Sub : Revised specification No. RDSO/PE/SPEC/AC/0061-2005 (Rev.1) for Roof Mounted AC Package Unit for LHB variant AC coaches.

SPECIFICATION FOR ROOF MOUNTED AC PACKAGE UNIT
FOR LHB VARIANT AC COACHES

RDSO/PE/SPEC/AC/0061- 2005 - (REV. 1)

S. No	Date of amendment	Revision/ Amendment	Reason
1	Dec. 2011	Rev.1	Specification of microprocessor controller separated, Servo drive, solenoid valve, capillary tubes, hot gas bypass system removed and other improved features incorporated.

RDSO/PE/SK/AC/ 0125 - 2009 (REV. 1)

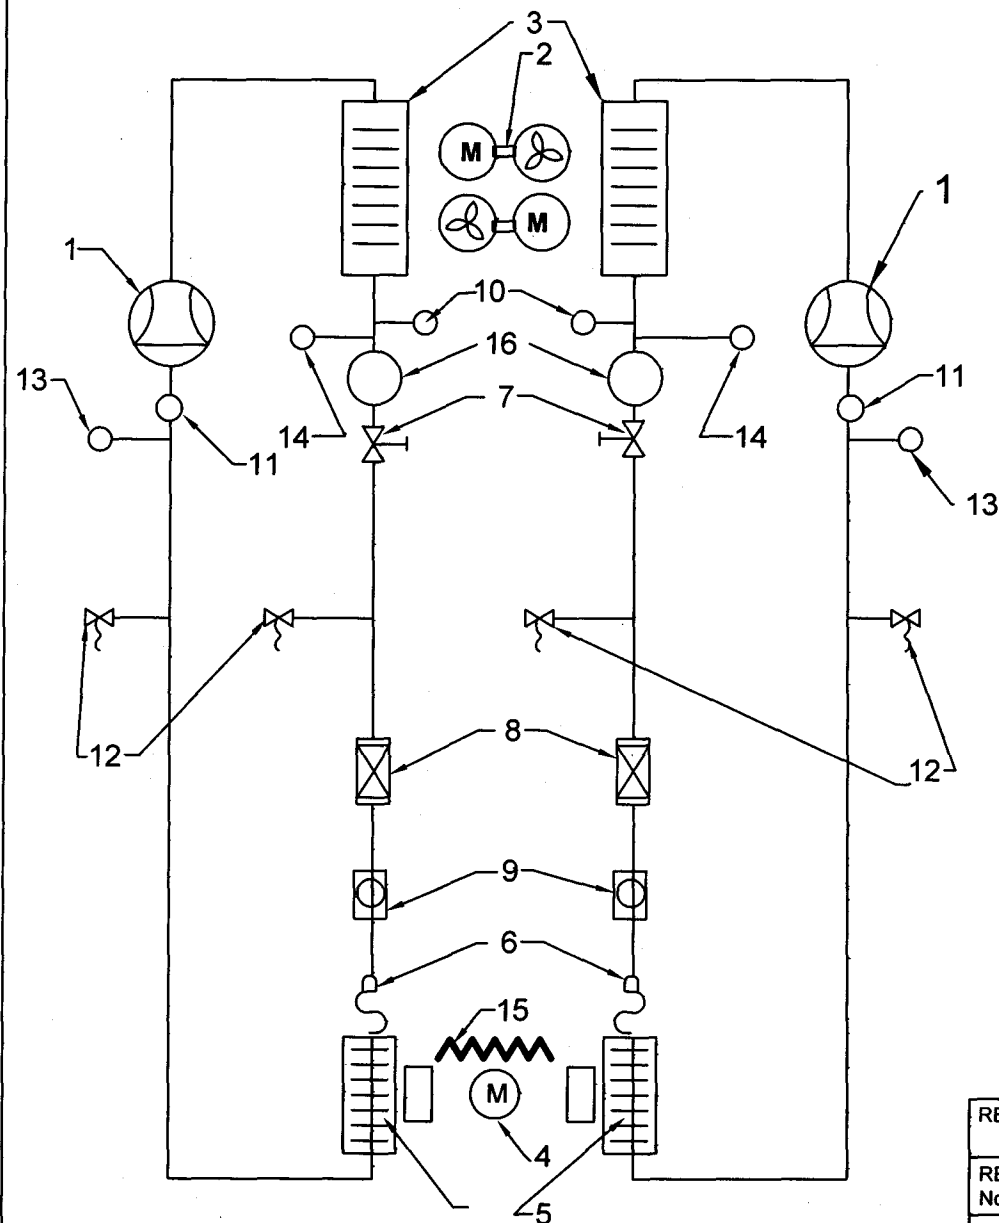
CHANGES IN REVISED DRAWING

NOTE CORRECTED AND SOME ADDITIONAL NOTE ADDED. TITLE CHANGED

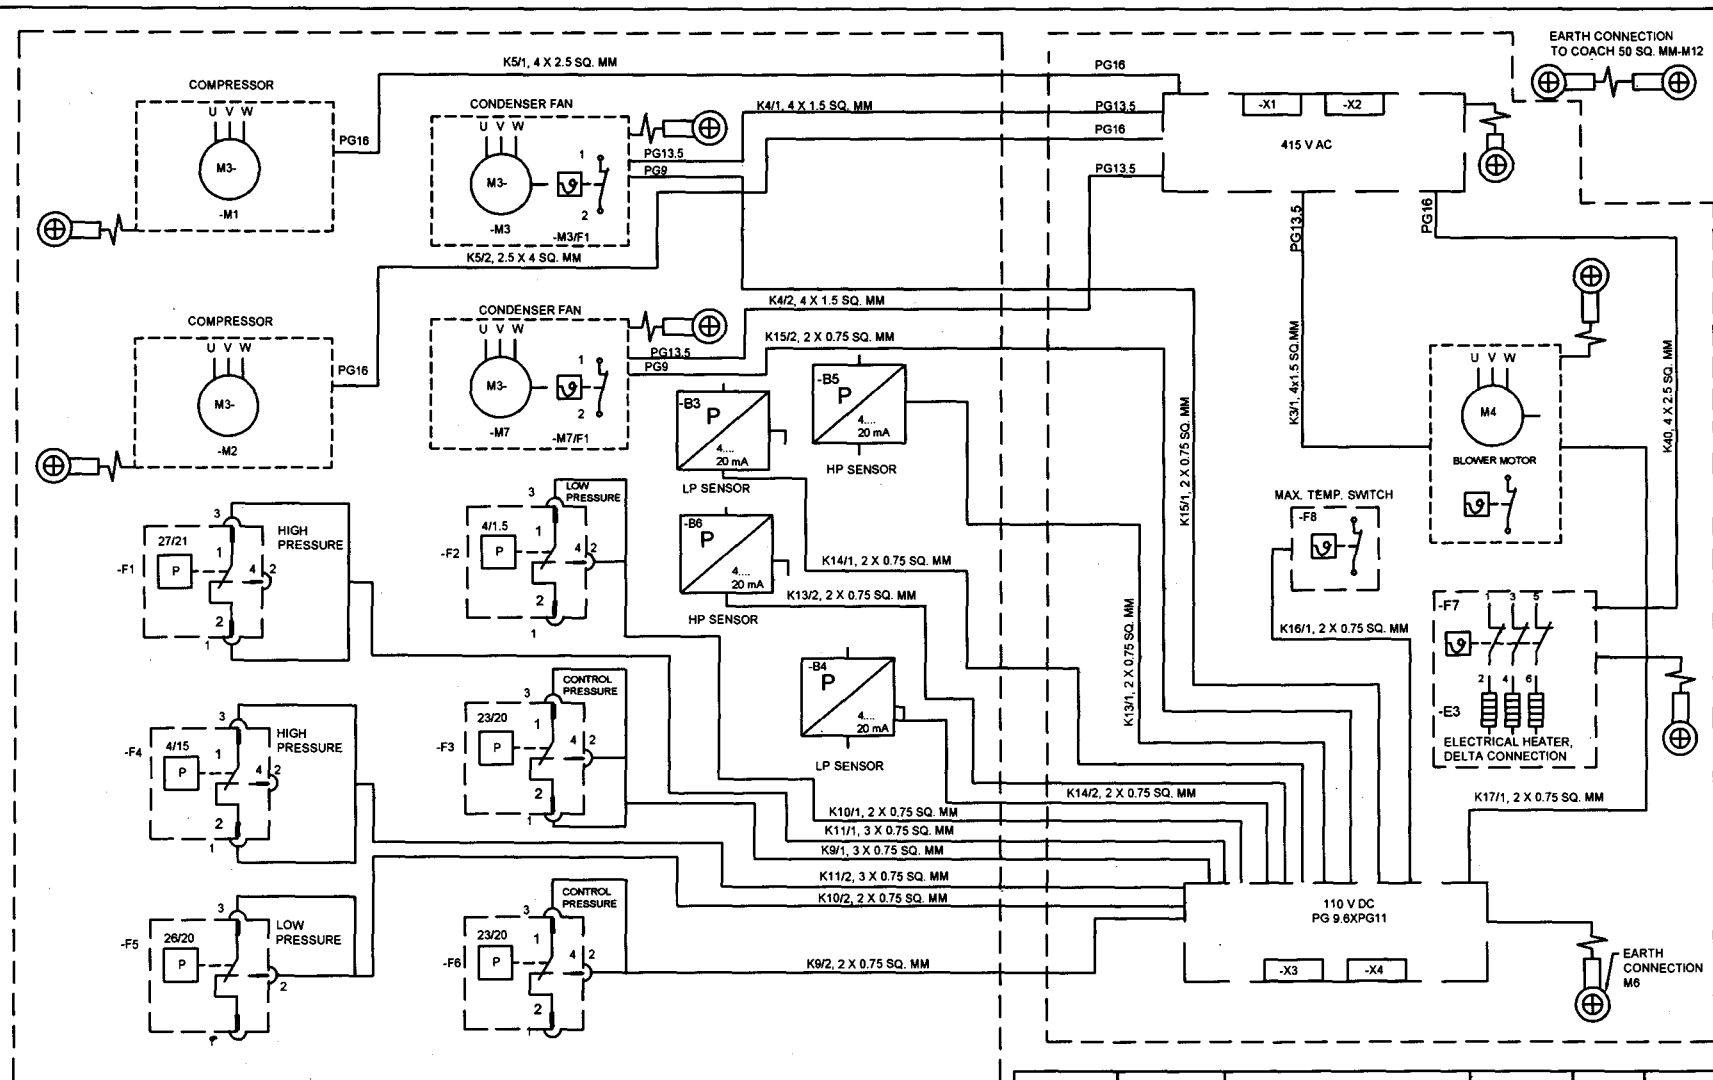
CHANGES DONE IN REVISED DRAWING

HOT GAS BYPASSED, ALL SOLENOID VALVE, SCHRADER VALVE DELETED AND EXPANSION VALVE ADDED. NUMBERING CORRECTED

REF. No	PART No.	DESCRIPTION	DRG No. DETAILS	No. OFF	MATL.	SPEC.
REF.:DRG. No. S65F-100.900-00A.V3			SCALE : NTS	APPROVED BY		
			FOR DG			
WIRING DIAGRAM OF RMPU (LHB VARIANT AC COACHES)				FIRST ISSUED		
				SUPERSEDS		
				SUPERSEDED BY		
RDSO/PE/SK/AC/0072 - 2004 (REV.'1')

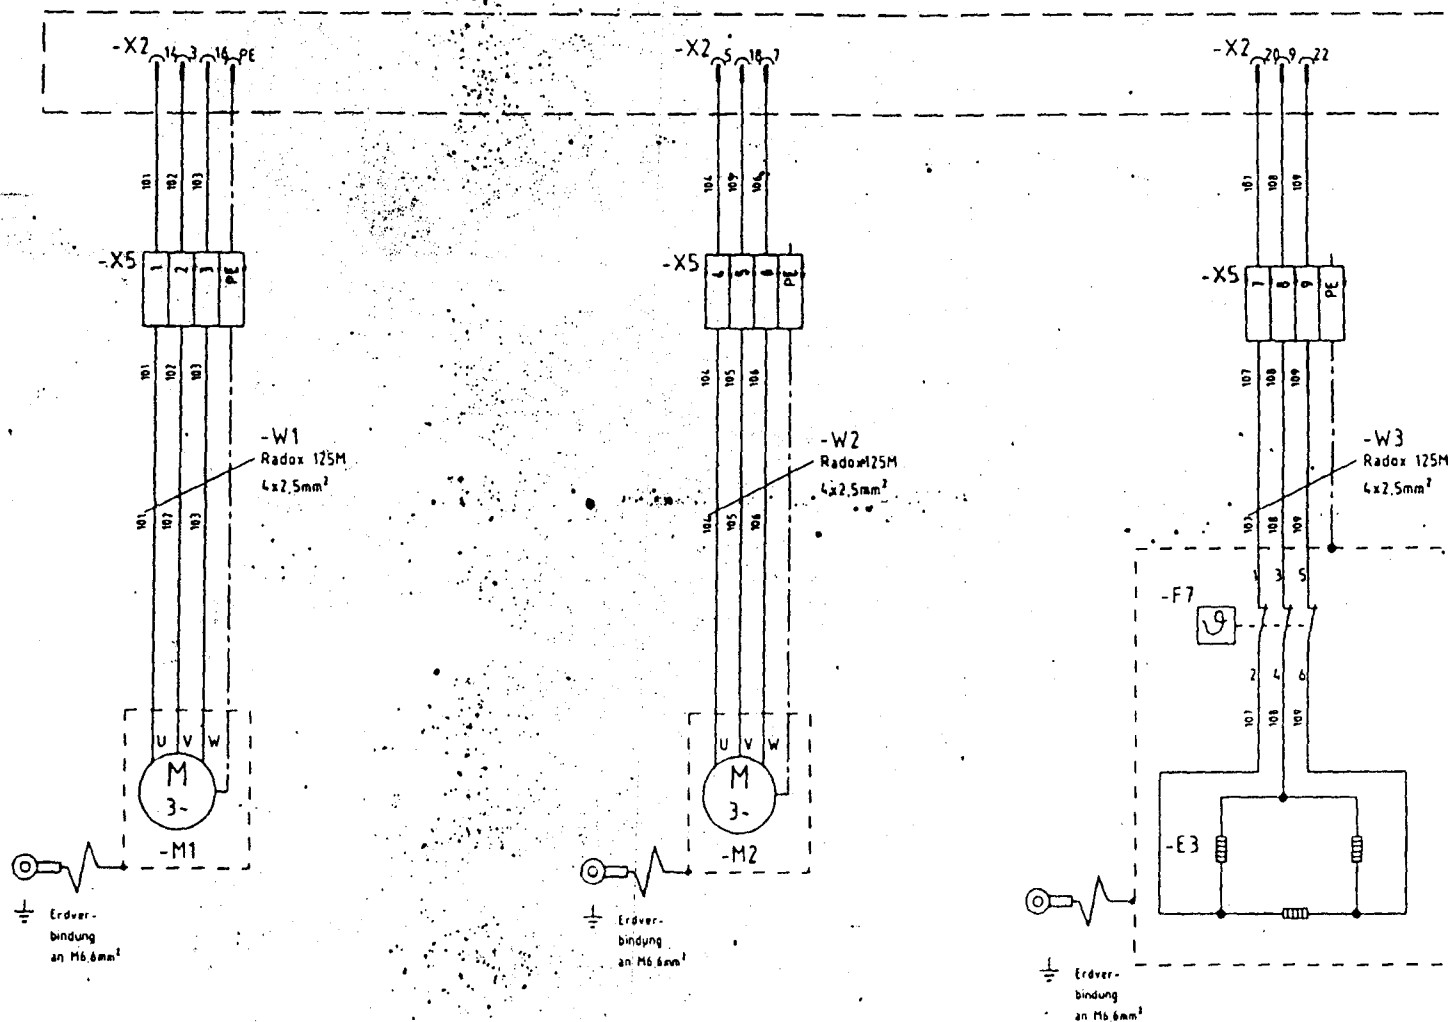
CHANGES IN REVISED DRAWING
ALL SOLENOID VALVES, CRANKCASE HEATER, SURVO MOTOR & THEIR WIRES DELETED.
